SUBJECT: COMMENTS ON TORREY PINES ZIMMER REPORT

OPE has reviewed the final report by Torrey Pines Technology (TPT) entitled, "Independent Review of Zimmer Project Management", dated August, 1983, and we offer the following summary of results and our comments in preparation for the briefing scheduled for September 28, 1983.

Report No. 50-358/84-01(USC)

Facility Name: Wm. H. Zimmer Nuclear Power Station

Fig. 1. Recommended Zimmer project management organization

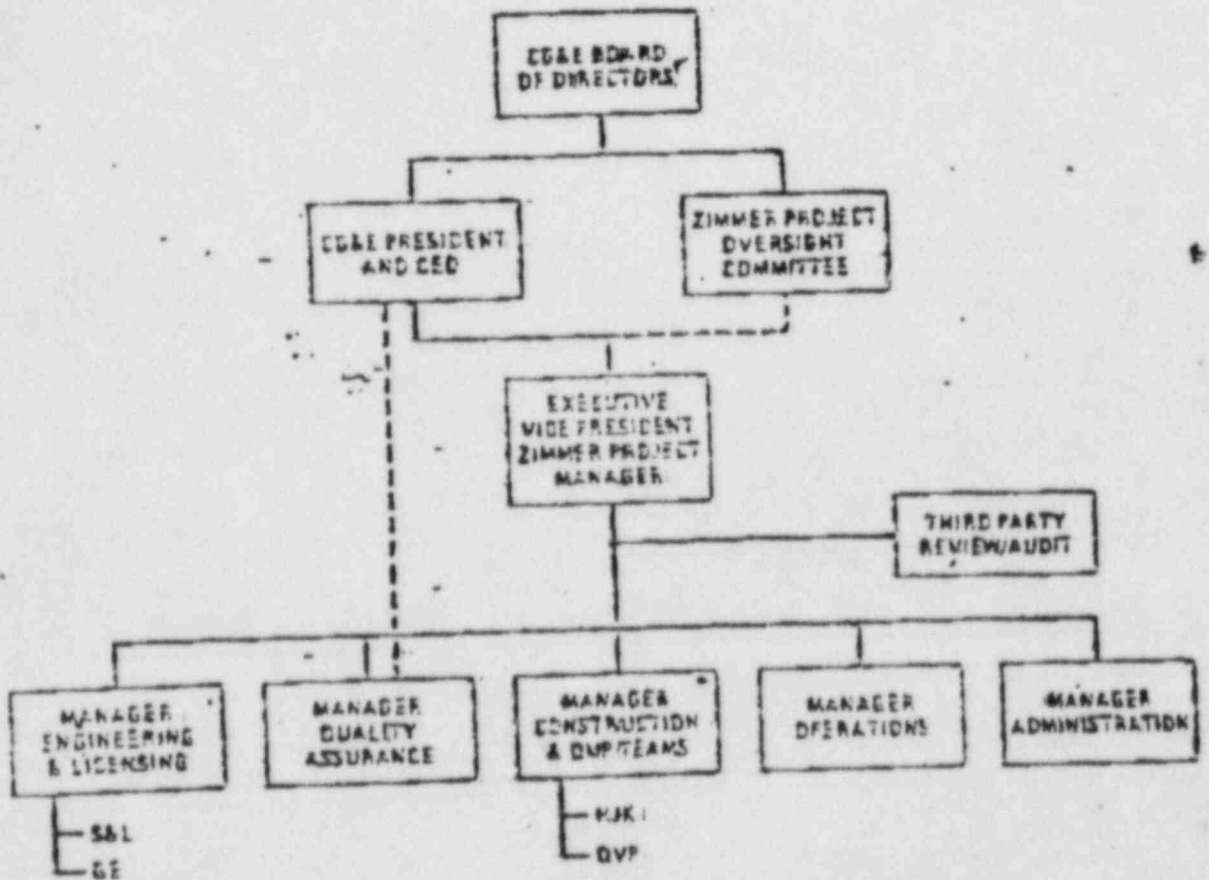
In light of the problems identified, TPT recommends an organizational structure such as shown in Figure 1, attached. This would include establishing a Zimmer Project Oversight Committee (ZPOC). It would strengthen and reorganize the Zimmer project organization within CG&E, having the Zimmer Project Manager (someone with no prior involvement with Zimmer) direct all aspects of the Zimmer project. In addition, construction management and management of the Quality Verification Program would be performed by an outside organization.

It appears that the organizational structure recommended by TPT addresses the problems identified during the course of the management review, problems which were fairly well known and previously identified by the NRC prior to the TPT independent review. The key consideration as stated by TPT is the Zimmer project management's policy, and attitude toward QA. The fundamental question then becomes whether the new ingredients will provide this commitment to quality and whether the previously responsible line managers who continue to be involved in the project have been successfully rehabilitated. TPT does not address this point but does endorse the existing President and the recently appointed Senior Vice President/Project Manager. We note that the TPT recommendation closely resembles the current organization in place, in that Mr. J. Williams has been appointed Senior Vice President and Zimmer Project Manager, and in that construction management and management of the QVP is being performed by Bechtel.
